Technical Service Information

DODGE 68RFE

VALVE BODY AND SOLENOID ASSEMBLY CHANGES FOR LATE 2010 AND UP

Figure 6

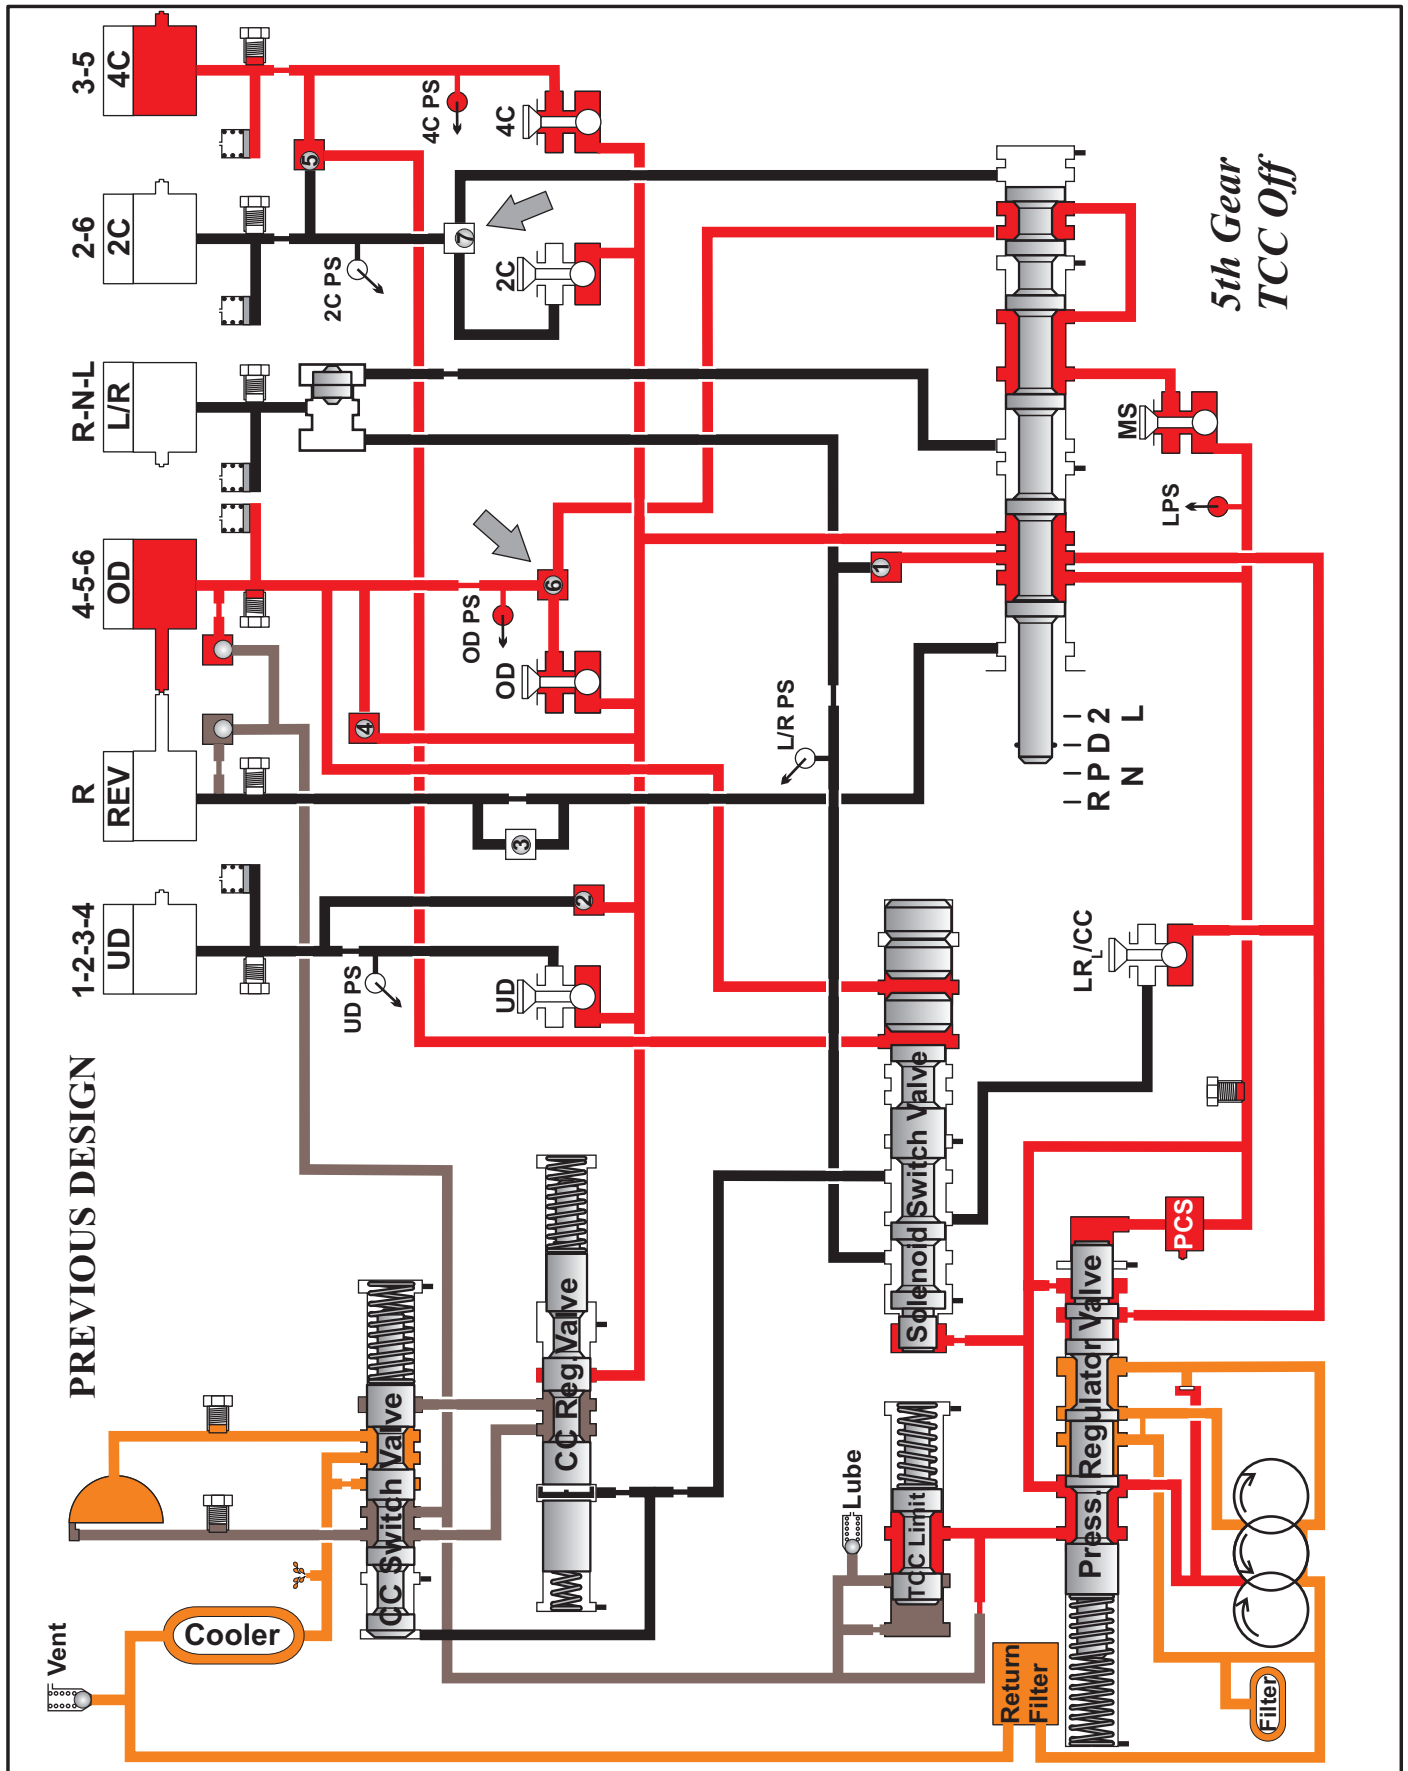
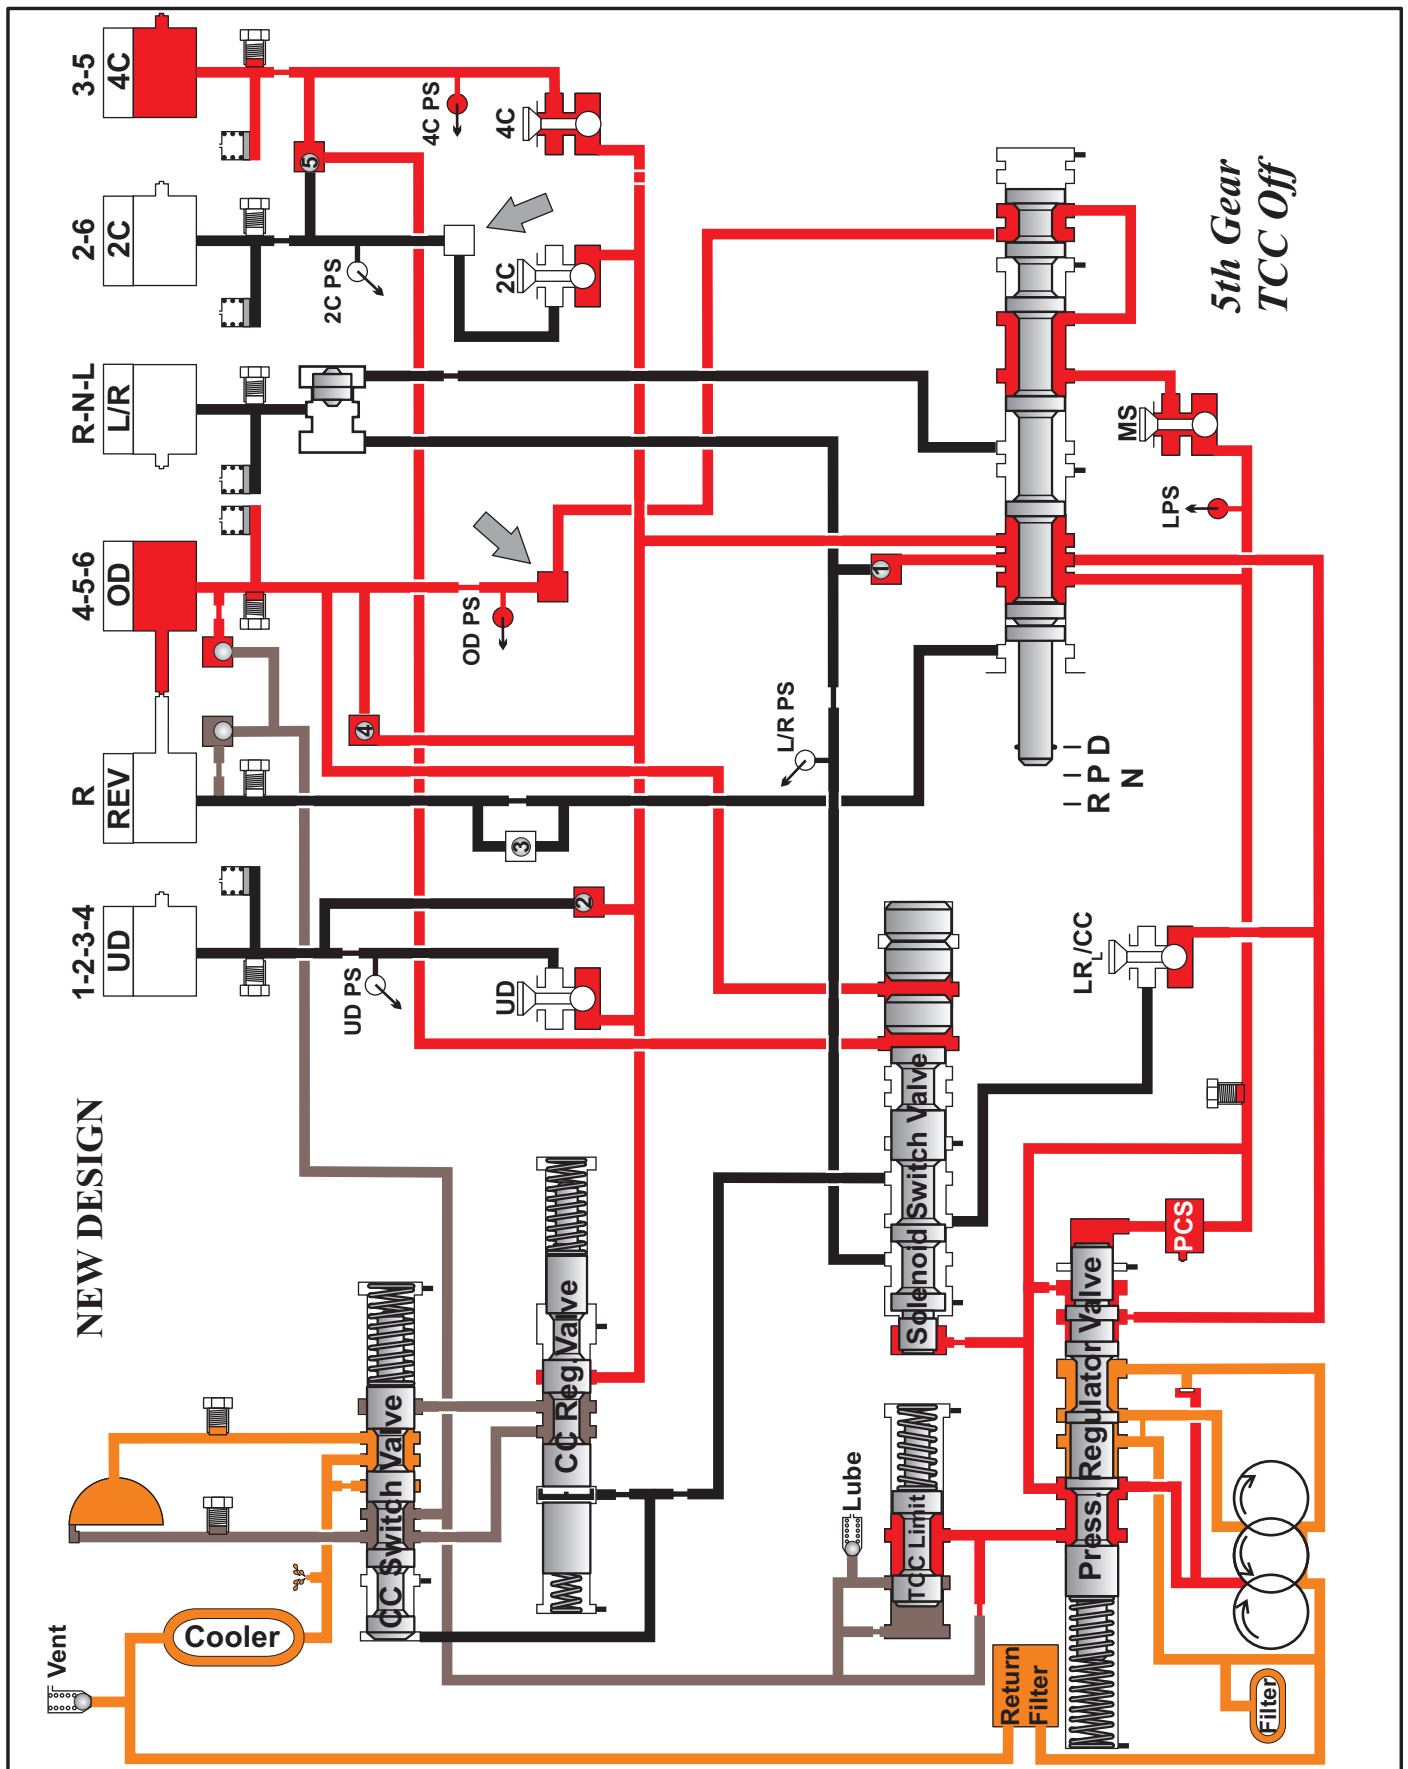
- **MAIN VALVE BODY-** The Main Valve body was anodized to help prevent Solenoid Switch Valve wear out. An exhaust passage was added in the top of the casting and the Manual Valve had a new land added to it with a small notch. Number 6 and 7 Check balls were eliminated. Refer to Figures 4 and 5 for a comparison of these changes from previous to new design. See Figures 6 and 7 for a comparison of the previous design oil circuit diagram using check ball 6 and 7 and compare it to the new design oil circuit diagram with the number 6 and 7 check balls eliminated and the Overdrive Solenoid eliminated.

Figure 9

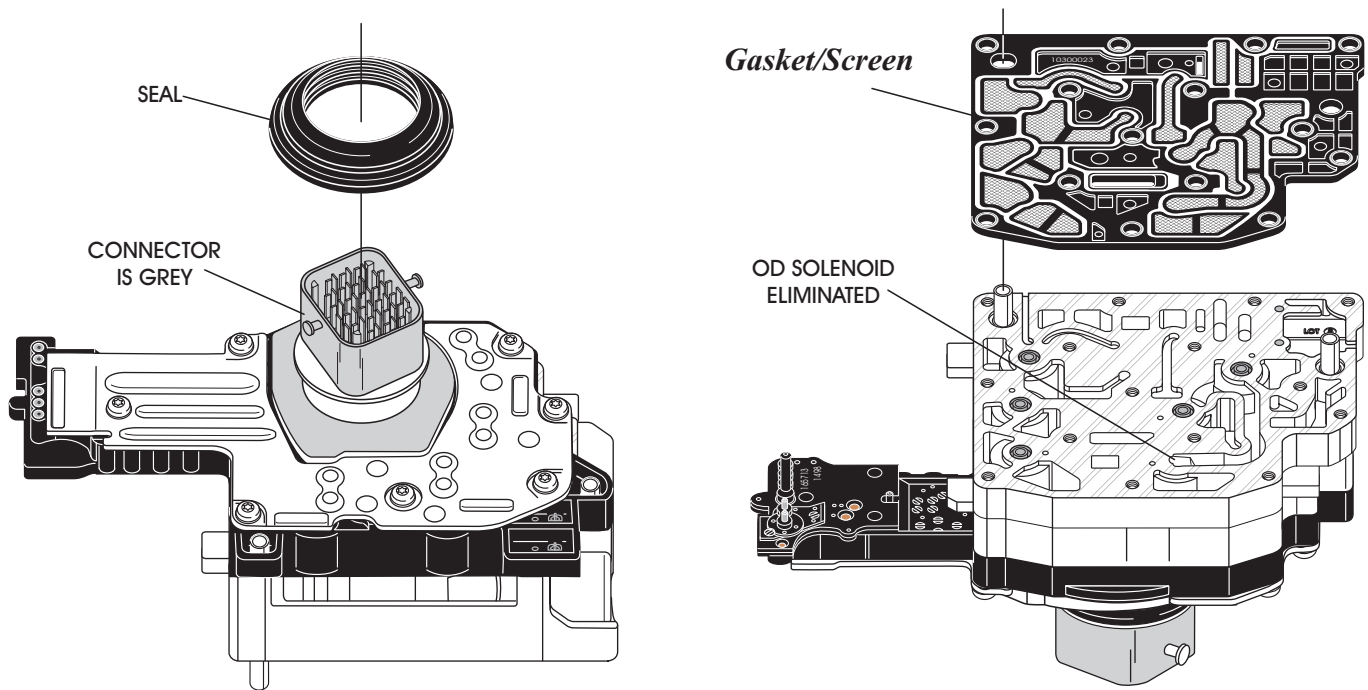
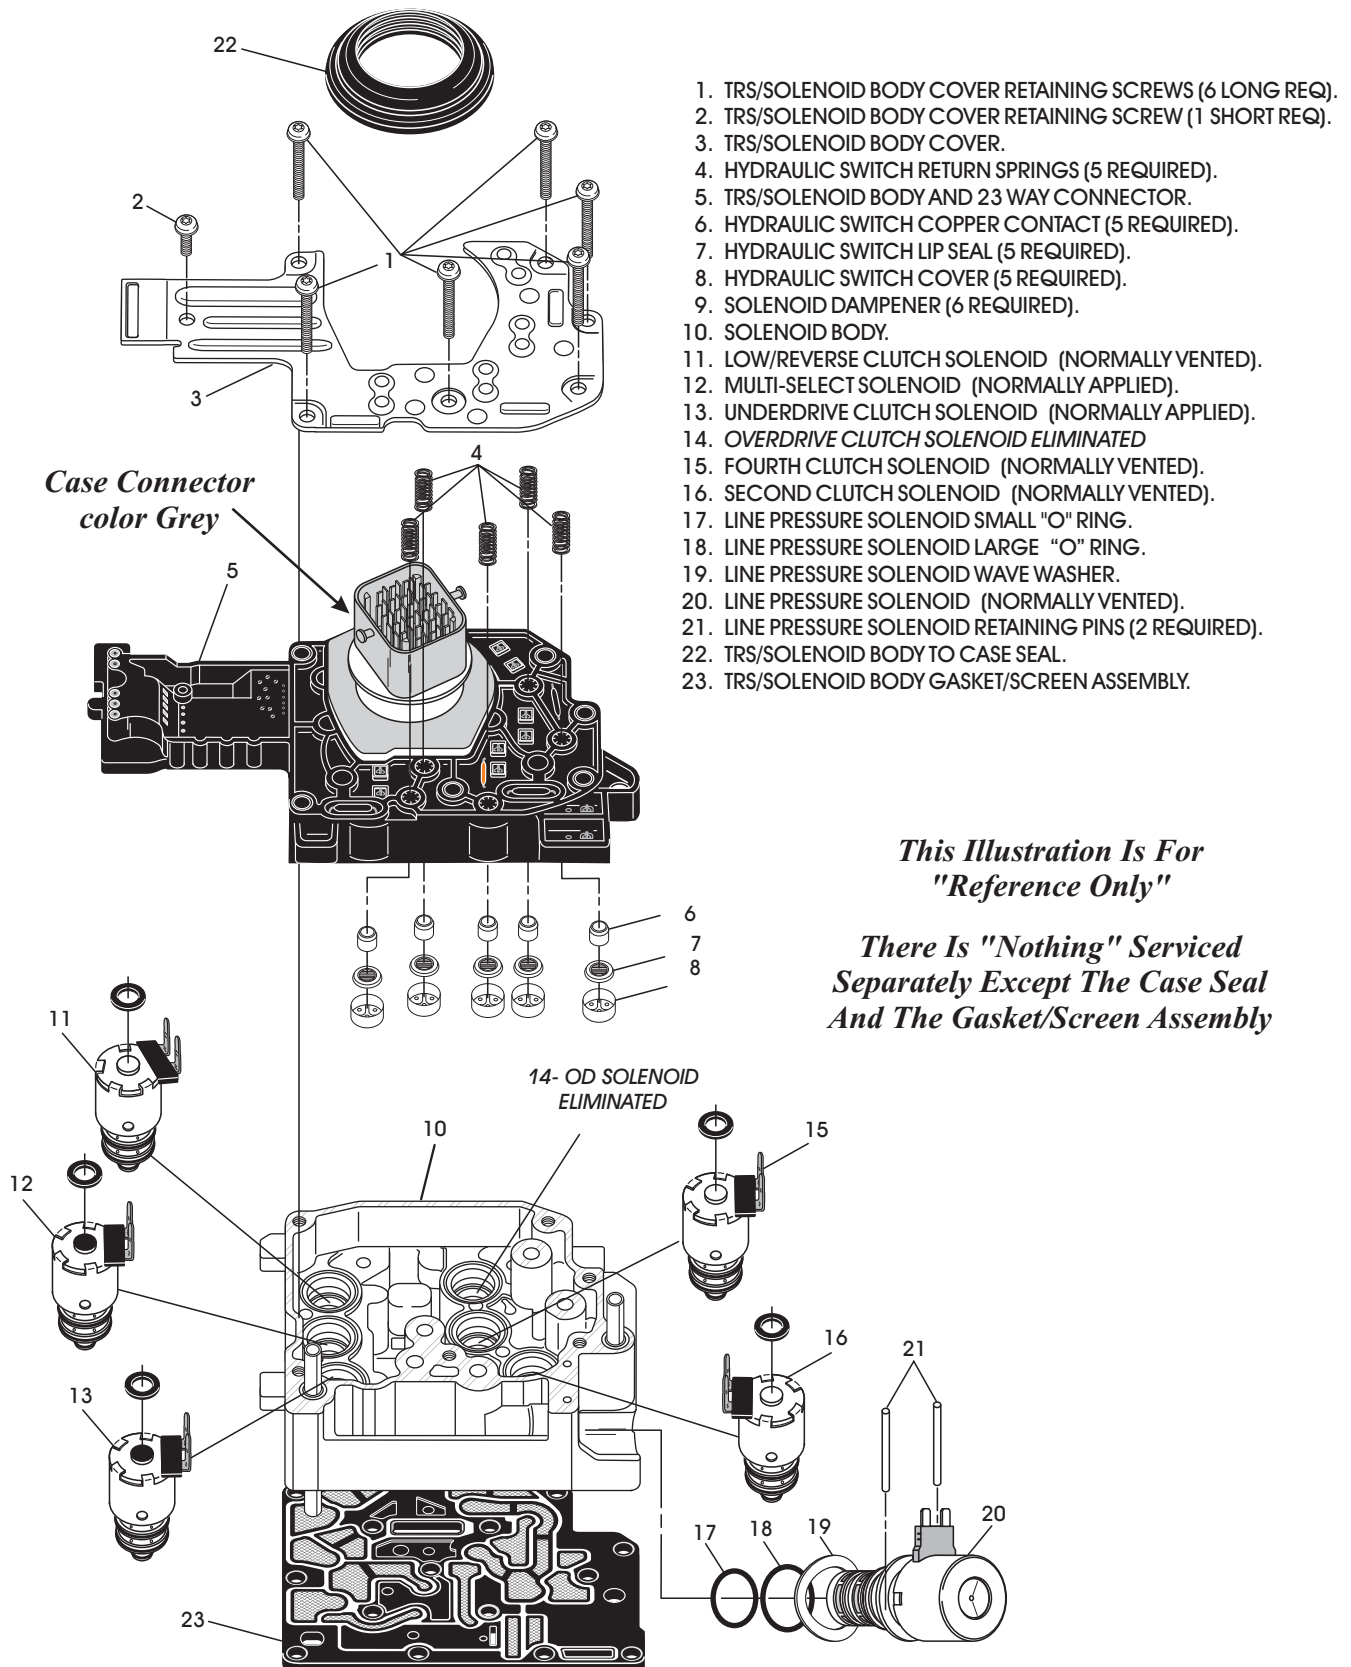
- **SOLENOID ASSEMBLY-** The Solenoid assembly had the Overdrive Solenoid eliminated. The Multi-function solenoid is now used for Overdrive clutch apply solely. Refer to Figure 8 and 9 for identification and exploded view.
